PWR Owners Group
NRC Public Meeting – December 16, 2009

Jet Impingement Issue Resolution

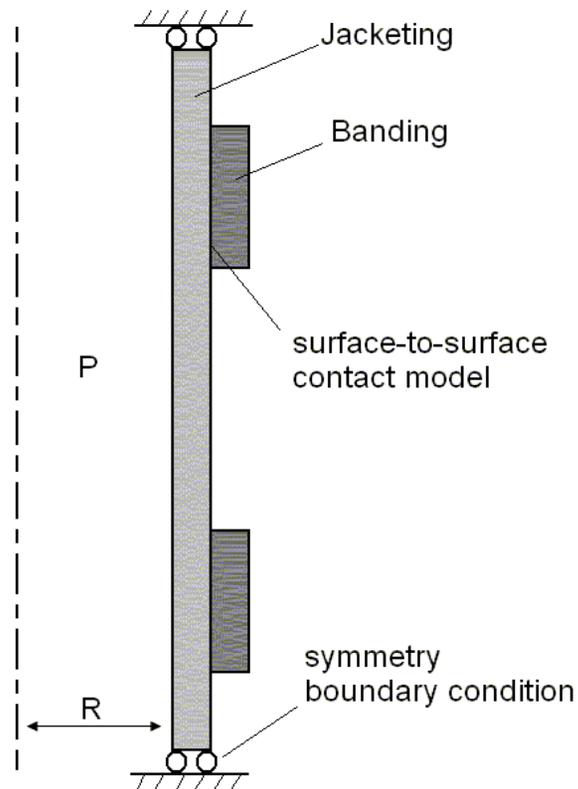
- 2A *Larger pipe sizes in the plant as compared to test configuration may result in different failure mechanisms.*
- 2D *Jacket tears due to lip lifting by the jet may not be the failure mode on large pipes. In addition, most plants use stainless steel jacketing which is stronger than tested aluminum, therefore lift forces may damage the banding and latches resulting in greater loss of jacketing.*

Potential failure mechanism other than jacket tearing would be breakage of the bands or clasps holding insulation in place.

Load mechanism: Pressurization of entire interior of jacket, with external load due to jet impingement pressure on the front side of the jacket.

Finite element models will be developed.

- Three-dimensional models using tetrahedral plate/shell elements
- FEA package: Solid Work Simulation (non-linear capability)
- Model 1: Jacket with bands (for CalSil systems)
- Model 2: Jacket with linear elements to represent clasps (Nukon systems)

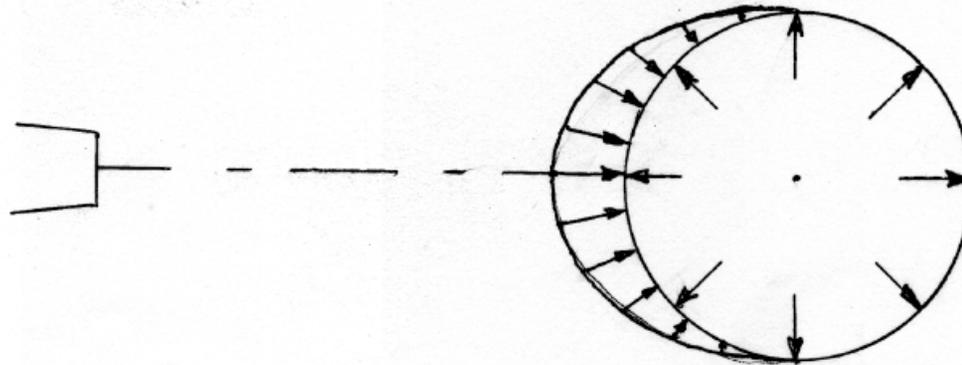
ISSUE #2A/2D (cont.)

- Loading
 - Each model will be loaded to represent external and internal pressure due to jet impingement.
 - Stagnation pressure from NUREG/CR-2913 corresponding to ZOI of 8.0 internally. Same pressure externally at jet centerline, decreasing linearly to zero at +/- 90° positions

Blowdown Pressure History for a
Westinghouse 4-Loop PWR in a Large
Dry Containment

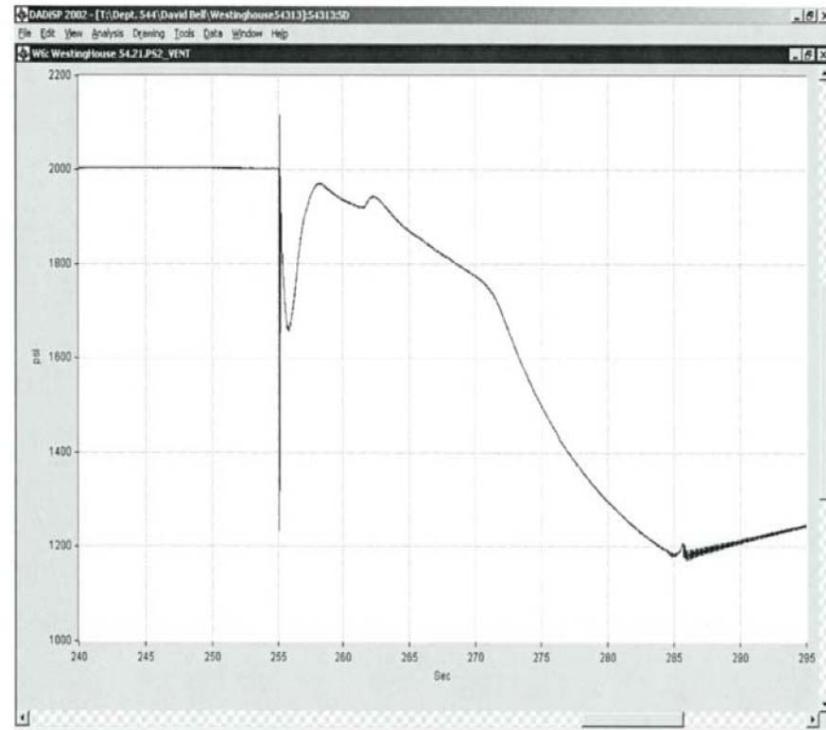
Question #3: The pressure of the tank decays as the test progresses. What is the influence of this pressure decay on the jet impingement test results?

Proposed Response to Question #3:

- Two pressure histories are given on the following slide
 - A postulated LOCA for Westinghouse 4-Loop PWR in a large dry (not an ice condenser) containment
 - A representative pressure history in the test tank during a test (ZOI = 5D test)
- Comparing the two pressure histories, the supply tank pressure of the test did not decay as was predicted for the RCS
- The elevated pressure in the supply tank provides for the test article to be subjected to a larger mass flux than would be the case for the postulated LOCA
- It follows that the test provides for bounding jet loading conditions compared to the plant

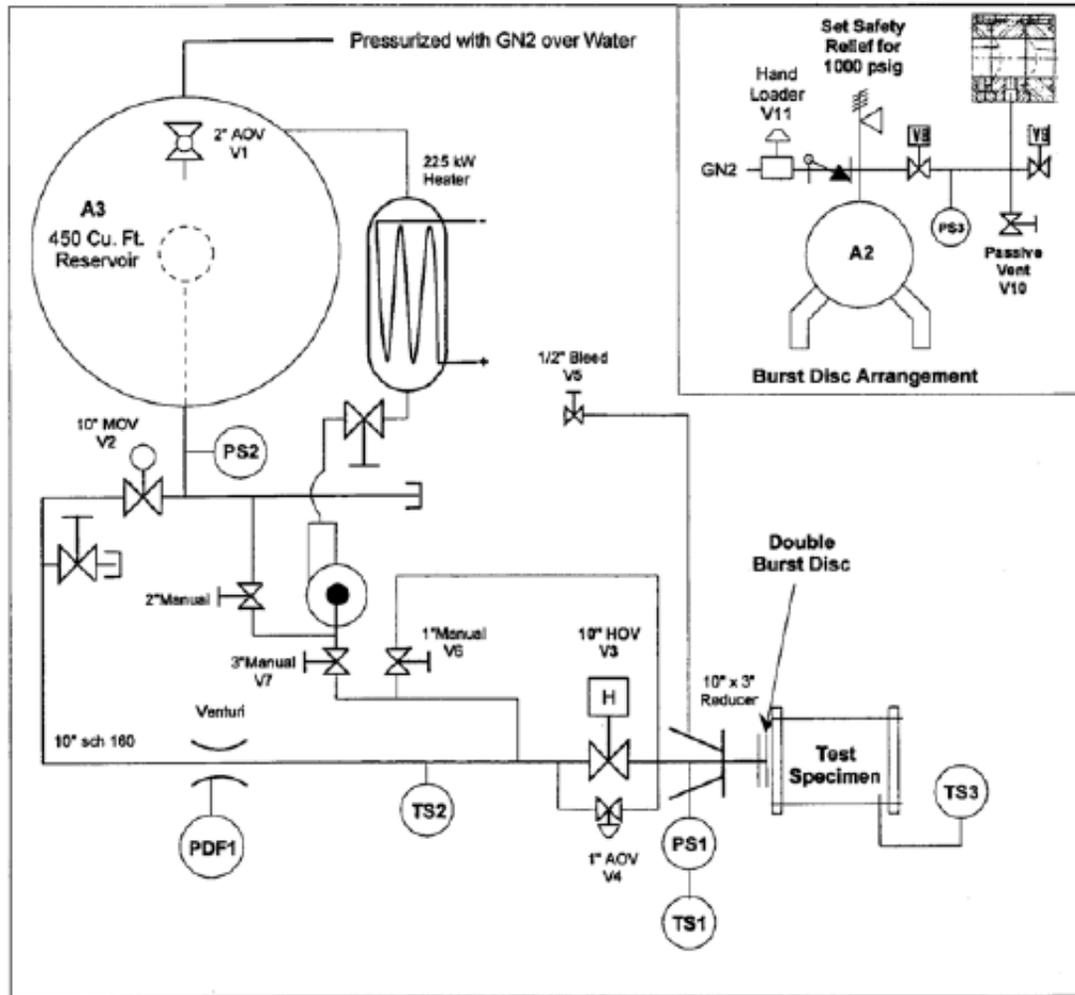
5. *Provide a detailed description of the test apparatus specifically including the piping from the pressurized test tank to the exit nozzle including the rupture disk system.*

Proposed Response:

- The tests were performed at the Hot Water Blowdown Test Facility at Wyle Laboratories (Huntsville, Alabama)
- A schematic and brief description of the test loop is given in Appendix A of WCAP-16710-P and is repeated herein
- In preparing a detailed description of the test facility for NRC
 - It was determined that there was a choke point upstream of the 3.54” nozzle
 - The minimum dimension of the reducer feeding into the burst disk assembly is 2.615”
 - This dimension controls the choked flow rate
- Westinghouse has entered this issue into their Potential Issue (PI) process
- The process is being followed to address this issue
